Request for Revision of Monitoring Plan

“2.5 MW BEL grid connected Wind Power Project at Davanagere District, Karnataka, India.”

CDM Registration No: 1216

Validation opinion as per requirement of EB49, Annex 28, para 9

The metering arrangement is as follows:

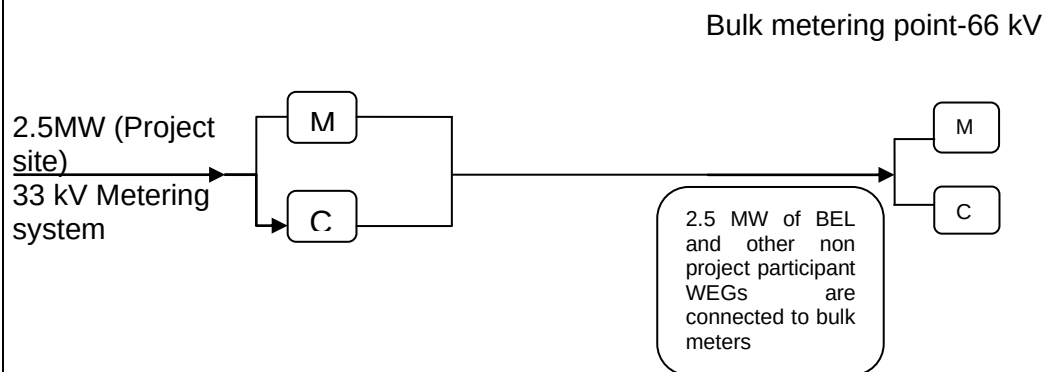
By reviewing the JMRs^{/JMR1, JMR2/}, and wheeling and banking agreement and conducting interviews with PP, the validation team confirms that the transmission loss procedure mentioned in the revised MP is accurate. Transmission loss will be calculated by the state utility and applied in monthly joint meter reading as per procedure set in Article 6 of the signed wheeling and banking agreement. The calculation procedure of transmission loss is as follows,

1. Every month a joint meter reading will be prepared at 66 kV metering point for the energy export and import value for the whole wind farm. **(Y)**
2. Other than bulk meter monthly JMR, there are project site energy meters which are installed at 33 kV metering point for monthly energy generation.
3. The sum of energy exported by all the WEGs will be calculated as **(X_i)**, which is equal to $X_1 + X_2 + X_3 + \dots + X_n$
4. As per the procedure mentioned in the wheeling and banking agreement, the transmission loss **(T_E)** will be calculated by the difference between the sum of energy exported by all the WEGs which is measured at 33 kV metering point **(X_n)** and energy exported value measured at 66 kV bulk metering point **(Y)** divided by sum of energy exported by all the WEGs **(X_n)**.

$$Z = (X_1 + X_2 + X_3 + \dots + X_n) - Y / (X_1 + X_2 + X_3 + \dots + X_n) * 100$$

5. The percentage transmission loss will be calculated for every month and the value will be applied to energy export value measured at each 33 kV metering point by the state utility.
6. All the transmission loss calculation procedure will be entirely under the control of state utility and the project proponents of WEGs will not have any control over the transmission loss calculation procedure and readings.
